Access Compliance Report

Public Rights-of-Way

Intersection ID: 30464	Main Street: BUBBLING_BROOK_CT	Cross Street: PLANTERS_ROW_DR	Location: SE
ADA ID: 5A2FBEA5C1D2	Ramp Type: PerpDiag	Initial Pass/Fail: Fail	Overall Compliance: No
Severity Score: 22.5			
Codes/Mitigation Info/Possible Solution		Field Measurements/Component Compliance

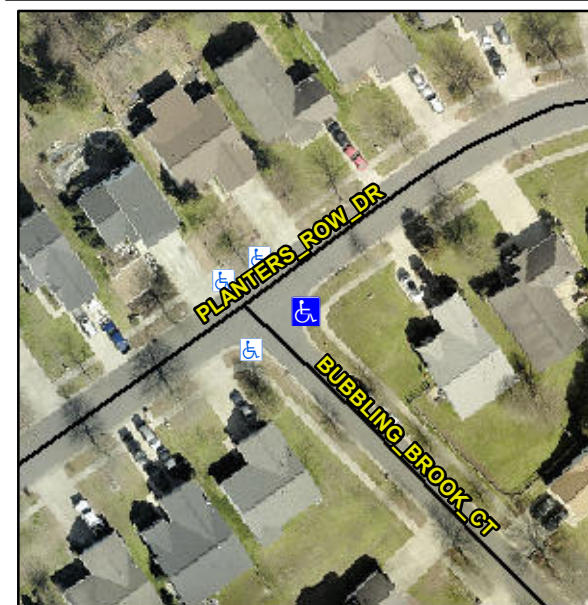
Not Found, R304.5.1, R304.2.2, R304.5.3

Compliance	Description	Data	Compliance	Description	Data
N/A	Ramp Length (in)	86.0	No	Ramp Slope (%)	11.3
No	Ramp Width (in)	47.5	No	Ramp XSlope (%)	2.8
N/A	Flare Type LT	N/A	N/A	Flare Type RT	N/A
N/A	Flare Slope LT (%)	N/A	N/A	Flare Slope RT (%)	N/A
N/A	Flare Traversable LT?	N/A	N/A	Flare Traversable RT?	N/A
N/A	Landing Length (in)	N/A	N/A	DWS Provided?	N/A
N/A	Landing Width (in)	N/A	N/A	DWS Contrast?	N/A
N/A	Landing Slope (%)	N/A	N/A	DWS Length (in)	N/A
N/A	Landing X Slope (%)	N/A	N/A	DWS Full Width?	N/A
N/A	Landing Curb? (Y/N)	N/A	N/A	DWS Offset (in)	N/A
N/A	Shared Landing?	N/A			
N/A	Gutter Ponding?	N/A	N/A	Gutter Slope (%)	N/A
N/A	Gutter Lip Ht (in)	N/A	N/A	Gutter X Slope (%)	N/A
N/A	Painted X Walk1?	No	N/A	Painted X Walk2?	No
	X Walk 1 Direction	To NW		X Walk 2 Direction	To SW
N/A	X Walk 1 Width (in)	N/A	N/A	X Walk 2 Width (in)	N/A
	X Walk 1 Slope (%)	2.6		X Walk 2 Slope (%)	1.5
	X Walk 1 X Slope (%)	0.8		X Walk 2 X Slope (%)	1.5

Remove & Replace Curb Ramp With Two New Directional Ramps or Equivalent.
